REPORT 26-03-R-006

DESIGN OF THE WES CENTRIFUGE

FINAL TECHNICAL REPORT

Title of Proposal: Phase 3B - Report on Quality Assurance for the WES Centrifuge

**Figure 1 Proposed operating envelope
for the Acutronic 684-1 centrifuge following the Final Design Review
(after Acutronic France SA)**

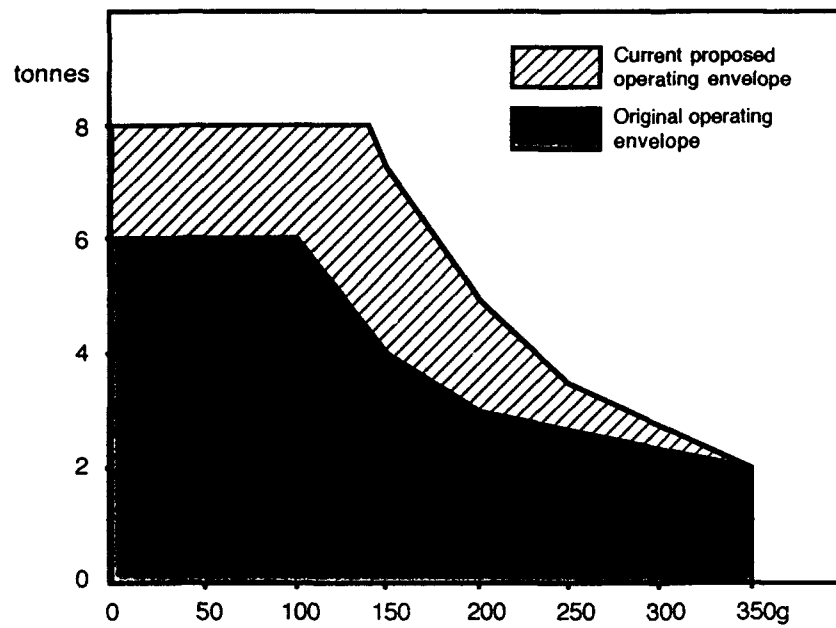
ANS&A recommend that the operating envelope of the centrifuge as designed be revised in the 150 to 350g range to fully benefit from the high load capacity of the swinging platform design. The operating envelope, which at present is limited in the mid-range by the limiting out-of-balance condition, can be pushed outwards without compromising the safety of the facility provided that the user can guarantee the integrity of the package under all failure conditions.

The operating envelope for the centrifuge is determined by a range of factors depending on g level, Figure 1. At one extreme, at high g, the centrifuge performance is limited by motor power. At the low g end, the performance is limited by the counterweight capacity. In the transition between these criteria of maximum payload and maximum g level the envelope is defined by two conditions: the limiting out-of-balance criterion and the platform stress limit. Unlike the peak power or maximum counterweight capability this section of the operating envelope is capable of being exceeded by a careless or irresponsible user and it is therefore important that the definition of this non-linear boundary is well-understood. The following numbers are broadly accurate but are for illustrative purposes only. Actual values will be defined in the Acutronic user manual.

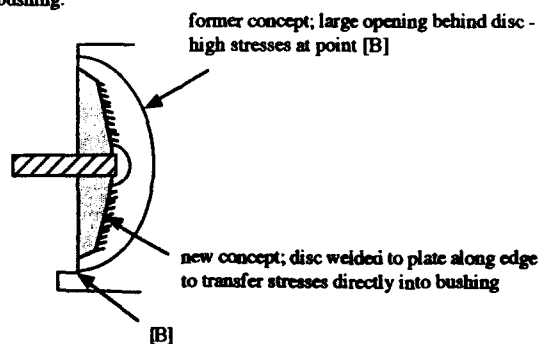
The details of the mesh (for the analysis of the slab) around the pins was discussed. It was explained that rod elements were used with radial spokes [A] connecting to the "bushing". The pin and bushing were considered to be a single unit, incapable of relative movement because the chosen taper of the pin (around 5°) was less than the friction angle of metal on metal (around 5.7°). When loaded it is considered that the pin cannot slide and therefore that modelling as a solid unit is acceptable. However the stiffness of the rod elements (such as [A]) are clearly the key to the rotational stiffness of the pin; this will be adjusted in further analyses to match the stiffness of the pins deduced from the pin analysis itself.

High stresses near [B] (which were a concern from the earlier plots) would be smoothed out by a proposed redesign of the back of the bushing.

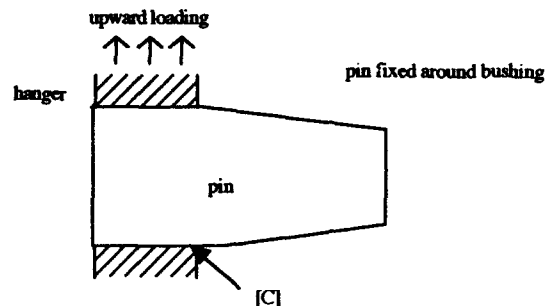
Pin/hanger stiffness will be applied to model of slab; a tension spring and a torsion spring would provide the appropriate restraint at the end of the rod element.

In the analysis of the pin/hanger joint the assumption of a fixed pin is an assumption of infinite rigidity in the platform. The hot spot identified under the pin at [C] will in practice be smeared out if some translation/rotation is applied to the pin. However, the assumption of infinite rigidity is considered to be a worst case for stresses in the pin itself.

Hanger

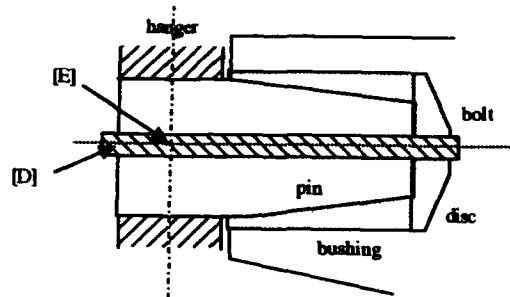
The three straps will give a minimum weight solution. Any alternative, such as a truss, would add considerably to the weight because of the need to transfer moment into the outer straps.

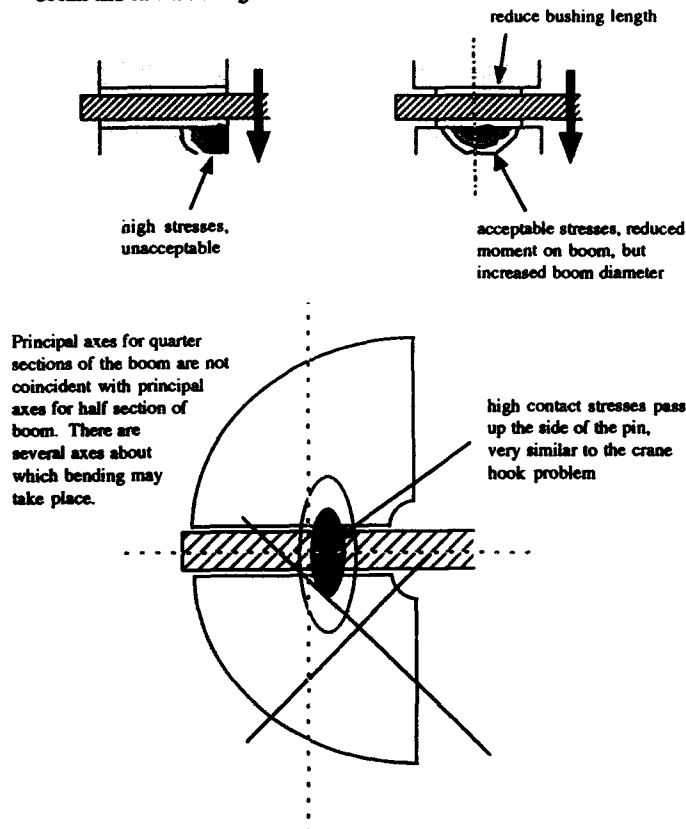
Arrangements for the supporting shroud were discussed. The attachment detail as presently configured is likely to lead to high stresses in the mounting due to compatibility of strain between the main strap and the attachment detail. This will need to be redesigned.

modify and remove metal here to reduce extensional strain
